CALIFORNIA TRAFFIC CONTROL DEVICES COMMITTEE (CTCDC) AGENDA (Revised)
September 3, 2015 Meeting (9:00 am to 2:00pm)

**Caltrans District 11
4050 Taylor Street
San Diego, CA 92110
Garcia Auditorium 1-125**

Figure 9C-107 (CA). Examples of Space for Bicycle Use with Right Turn Lanes

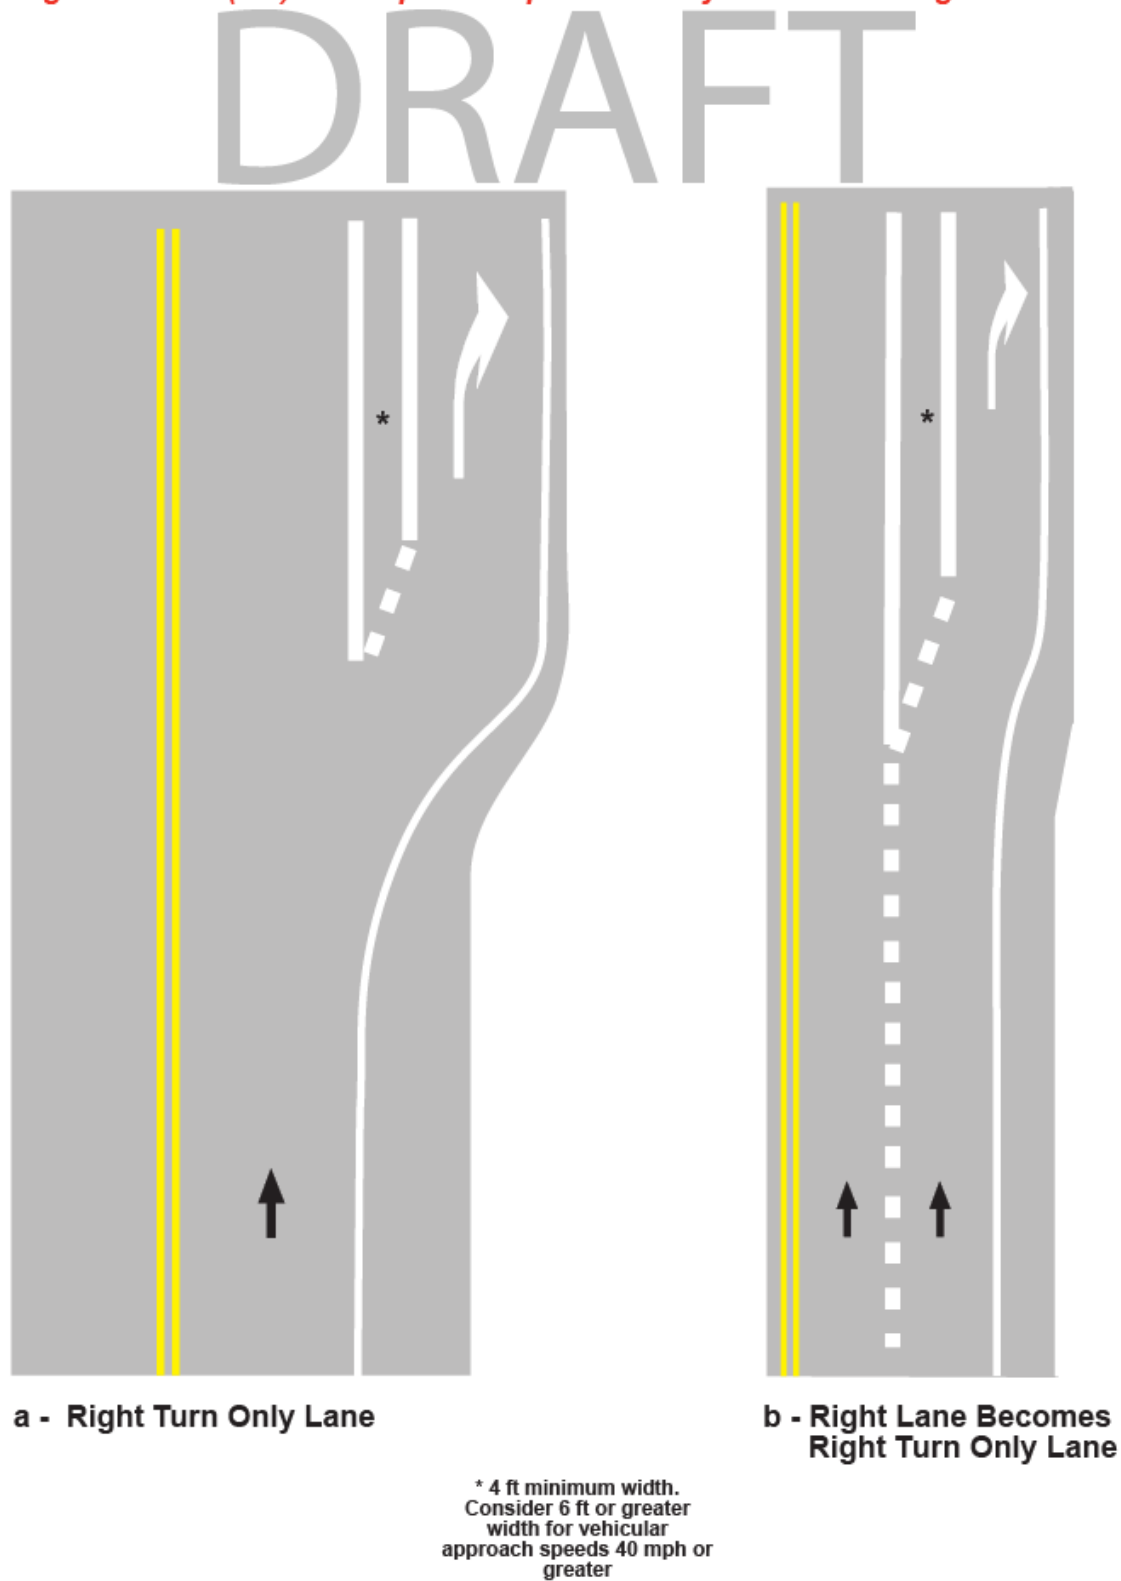
01 State highway locations with right-turn-only lanes where Class II bicycle facilities do not exist on the approach, but bicycles are permitted, a minimum 4-foot wide space for bicycle use should be provided between the right-turn and through lane. Where motor vehicle approach speeds are 40 miles per hour or greater, the minimum width for this bicycle use space should be 6 feet or greater.

04 If used, the space for bicycle use shall be delineated by Detail 38 on the right of the through lane and Detail 38A on the left of the right-turn-only lane.

05 In order to prevent a wider space from appearing as a lane, an optional 8-inch wide skip stripe may be utilized at the beginning of the space to guide motorists into the right turn lane.

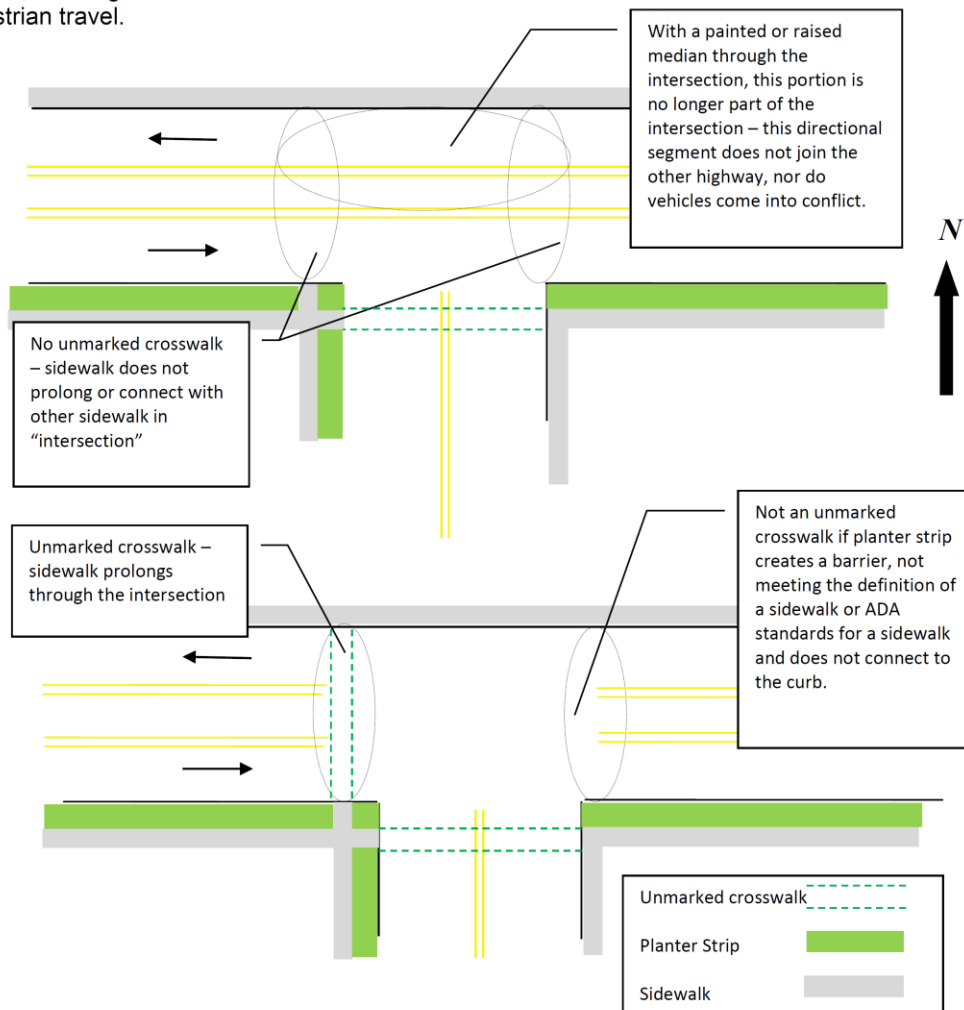
As such, using the lower part of the illustration on page 13, if a barrier, such as a planter strip, grass, or other vegetation separates a sidewalk from the curb, and the perpendicular sidewalk terminates at this barrier, an unmarked crosswalk does not exist in the direction across the east-west roadway on the easterly side of the intersection.

Figure 3B-22 (CA). Examples of Disabled Persons Parking Symbol, Legend and Related Markings (Sheet 2 of 2)

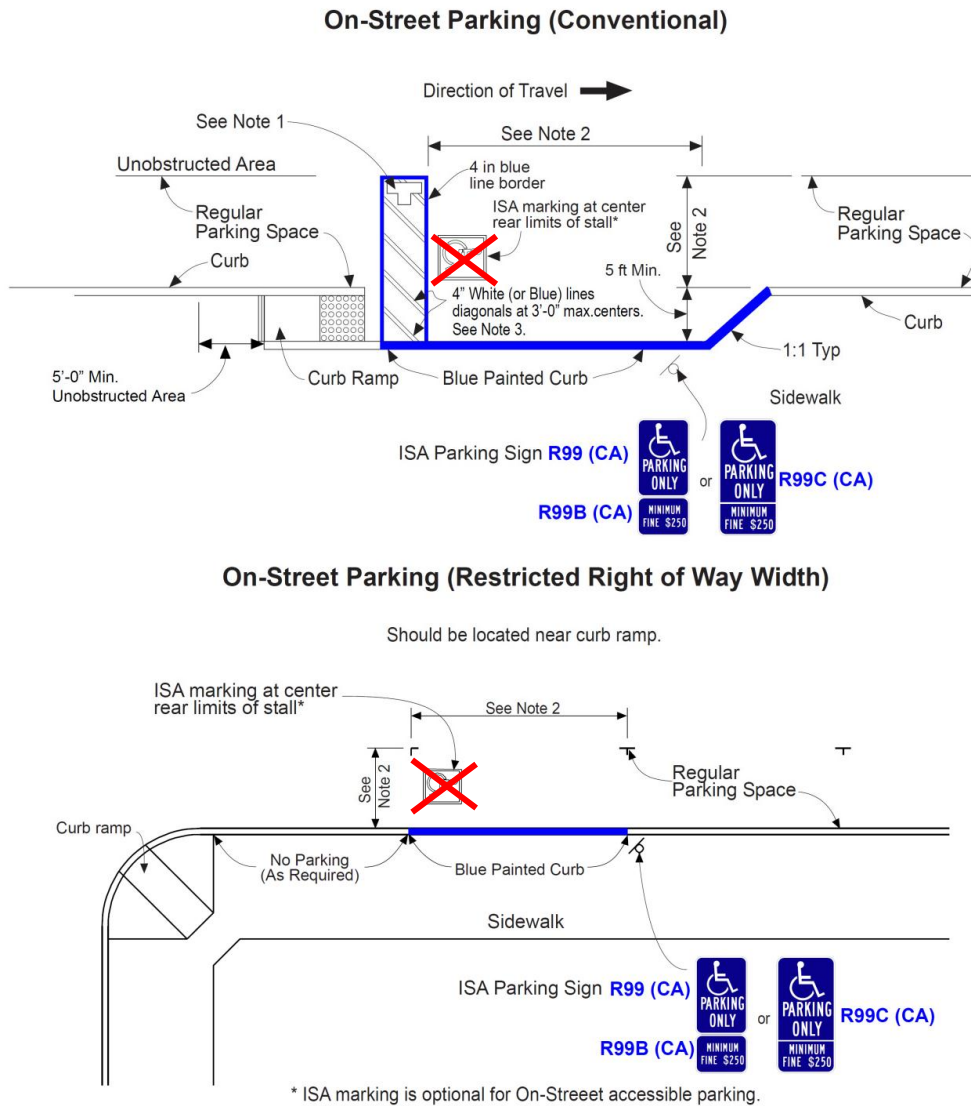
Request to make a recommendation to remove the ISA symbol in Figure 3B-22(CA) in the CA MUTCD.

Removing the ISA symbol in Figure 3B-22 (CA) within the on-street parking depiction would eliminate any concerns on the symbol’s use with on-street parking. Caltrans Revised Standard Plan A90B.

~~18a The ISA parking space marking (3B-22(CA)) should be placed in each on-street parking space designated for use by persons with disabilities.~~
